1977 Corvette: Service Bulletin: Anti-Theft Alarm System Interim Modifications

Model and Year: 1977 Corvette

Bulletin No: 77-I-38

Date: May 1977

FIGURE 1

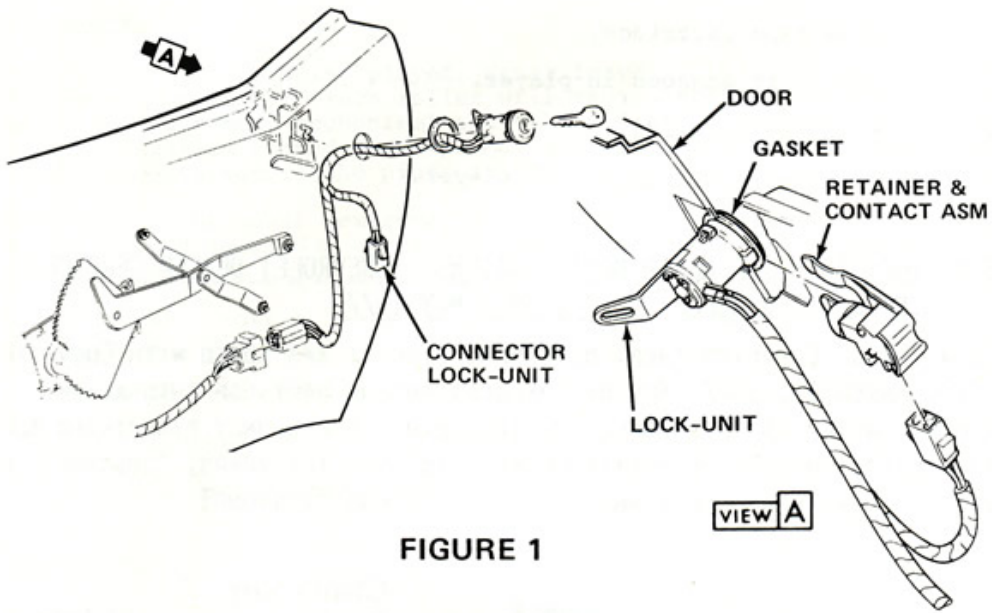
- The actuating switch for the system is no longer located on the left front fender. It has been incorporated into the left front door lock and must be activated by locking this door with the key from outside of the vehicle (Figure 1). This is the only way the alarm can be set. Turning the inside door knob to the locked position when exiting the vehicle will not activate the alarm system.
- The anti-theft alarm system horn has been moved from the left rear inner fender to the far left side of the engine compartment dash panel. (Figure 2).
- The anti-theft alarm system flasher assembly is now located on the console trim plate (Figure 3), rather than the rear compartment underbody panel.
- The new anti-theft alarm system wiring diagram is illustrated in Figure 4.
